STAFF RECOMMENDATION
1213 Linden Avenue
May 17, 2017

Application: New construction – addition
District: Belmont-Hillsboro Neighborhood Conservation Zoning Overlay
Council District: 18
Map and Parcel Number: 105130090
Applicant: Brittney Mount, Allard Ward Architects
Project Lead: Jenny Warren, jenny.warren@nashville.gov

<p>Description of Project: The applicant is proposing a rear addition</p> <p>Recommendation Summary: Staff recommends approval of the proposed addition, with the following conditions:</p> <ol style="list-style-type: none"> 1. Staff approve the design and materials of the proposed rear deck; 2. Staff approve the color of roofing material, and final details, dimensions and materials of windows, doors and skylights prior to purchase and installation; and, 3. HVAC and other utilities shall be located on the rear façade, or on the non-street-facing side of the house. <p>With these conditions, Staff finds that the proposed addition meets Sections II.B.1 and II.B.2 of the Belmont-Hillsboro Neighborhood Conservation Zoning Overlay design guidelines.</p>	<p>Attachments</p> <p>A: Photographs C: Site Plan D: Elevations</p>
--	---

First Floor Demo Plan

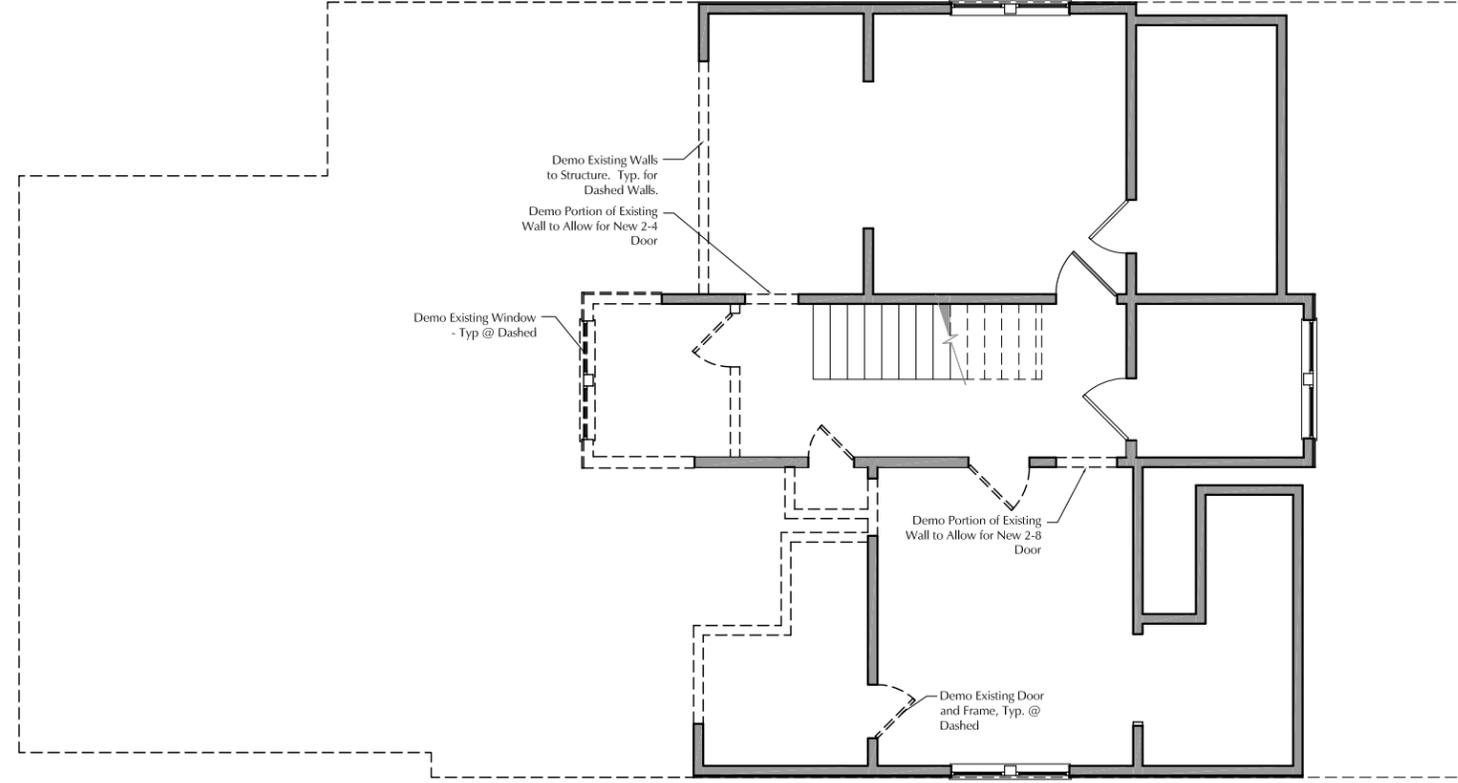
Partial Demolition: The proposed demolition work includes the removal of the rear wall of the house, including doors, windows and a second level dormer window. The majority of the demolition work is occurring in an area that appears to be an existing non-historic addition. Due to low public visibility, and the likelihood that the majority of the impacted area is a prior addition itself, Staff finds that the rear portion to be removed does not constitute a character-defining element of the house.

Demolition includes the closing-in of a window on the ground floor, right side. This window is not likely historic and because of its minimally visible location, staff finds removal to be appropriate.

1 South Elevation
Scale: 1/8"=1'-0"

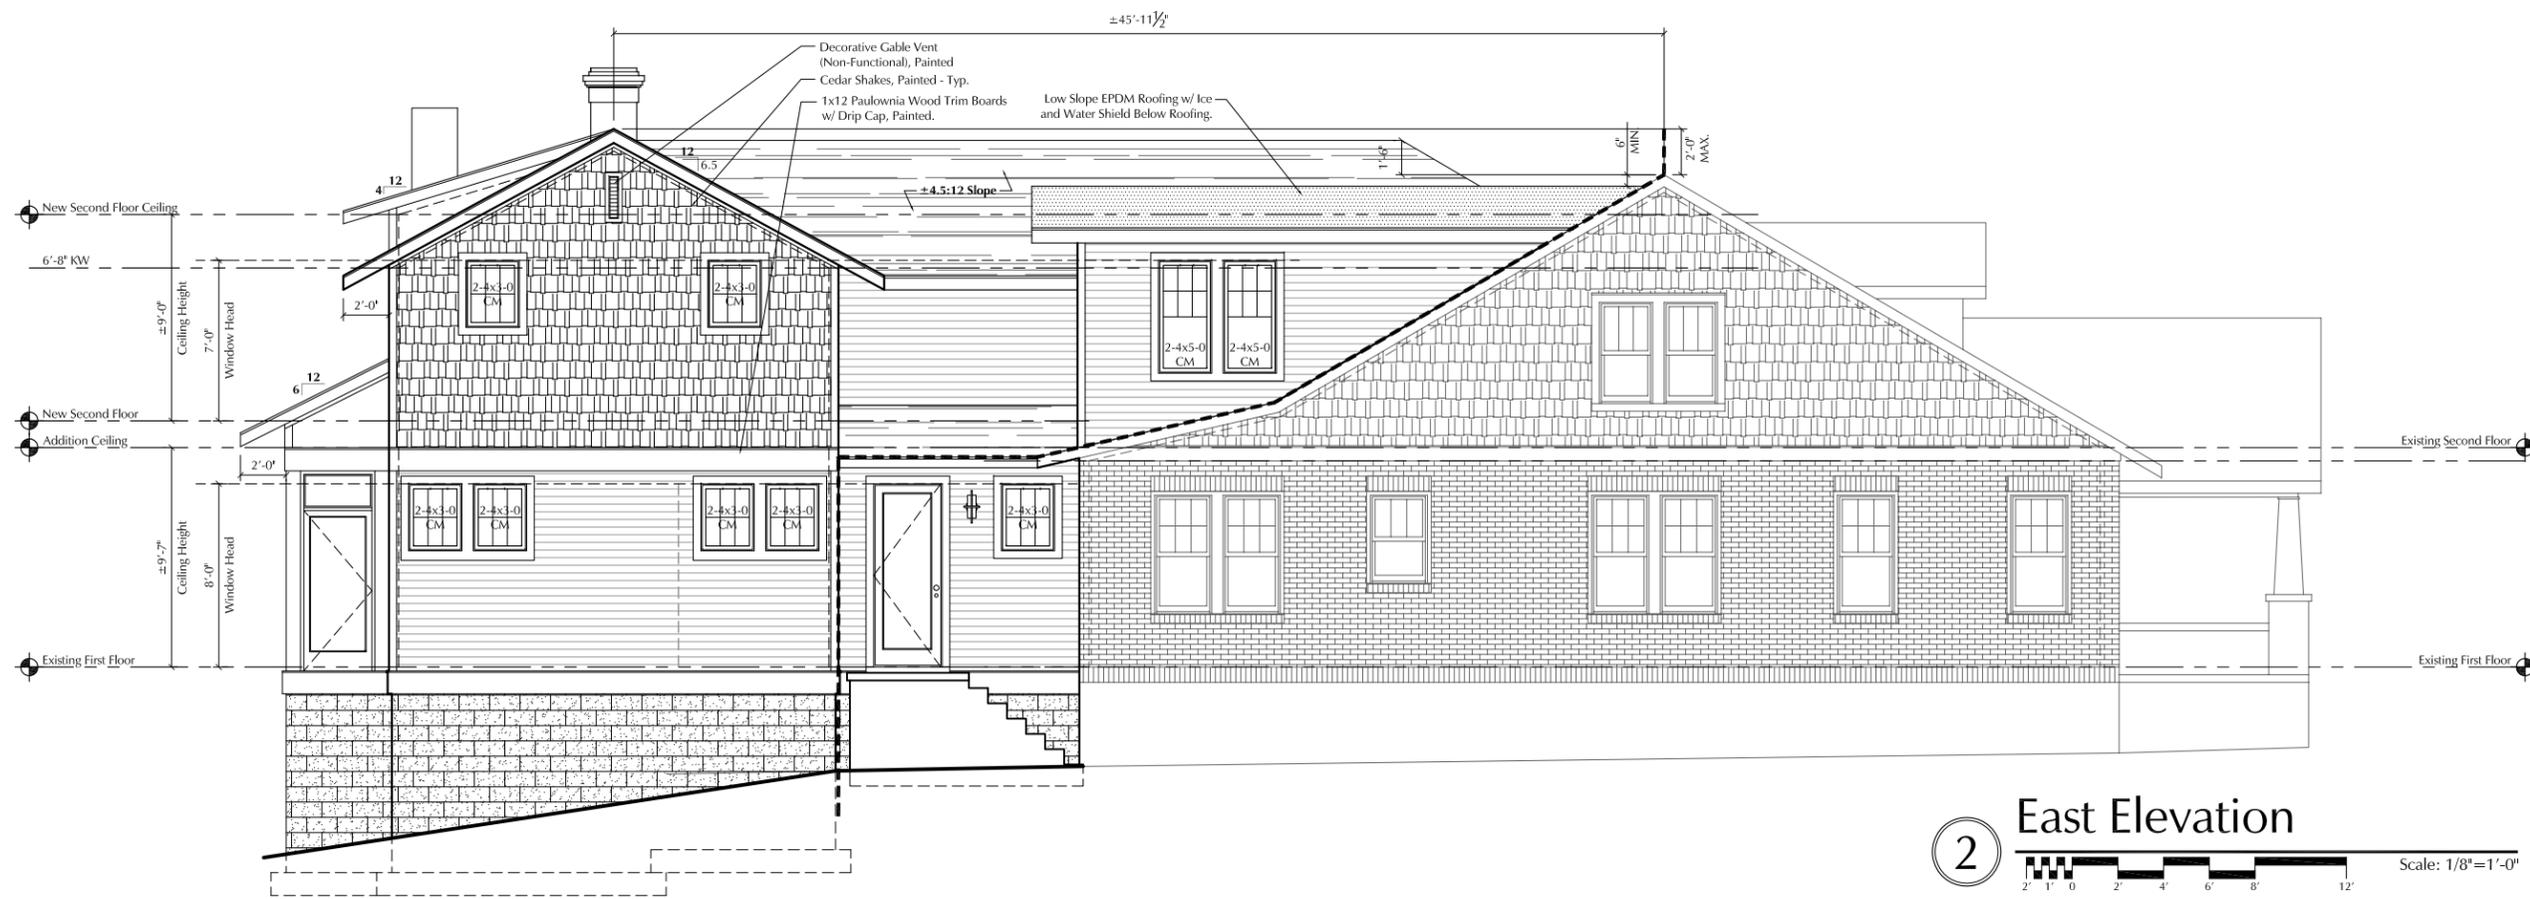
Roof form: The primary roof of the original house has a side gabled form. The rear of the proposed addition has another side gabled roof with a 6.5/12 pitch. The rear gable will be no more than two feet (2’) taller than the original roof height, as permitted by the guidelines. A connecting roof ridge will join the two gables. There is a dormer on the east elevation off the rear of the original roof. This dormer is set in two feet from the side of the primary roof, in accordance with the guidelines. The project meets section II.B.1.e.

1 West Elevation
Scale: 1/8" = 1'-0"

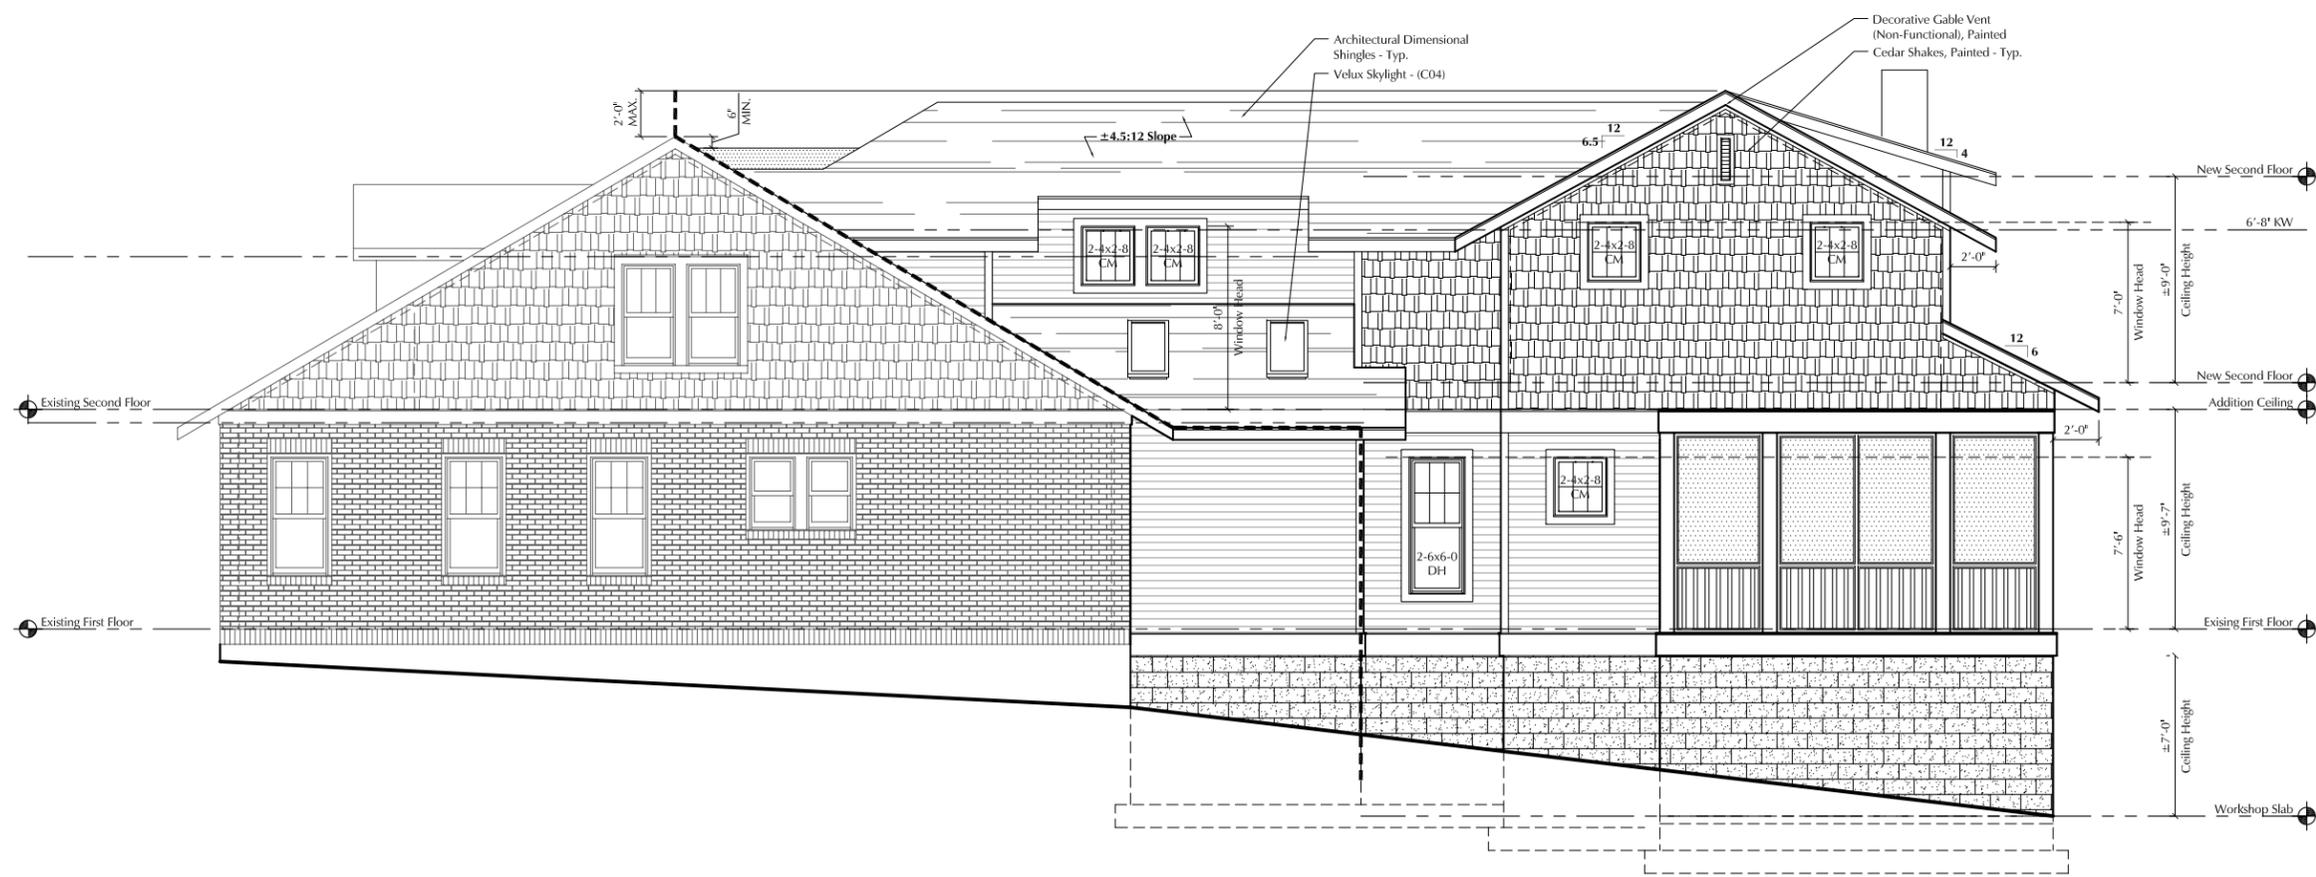
Proportion and Rhythm of Openings: The windows on the proposed addition are generally twice as tall as they are wide, meeting the historic proportion of openings. Along the west elevation (right side), first floor, there is a wall expanse of twenty-three feet (23') with no window; however, it is broken up with a change of materials and with different planes. Staff finds the project's proportion and rhythm of openings to meet Section II.B.1.g.
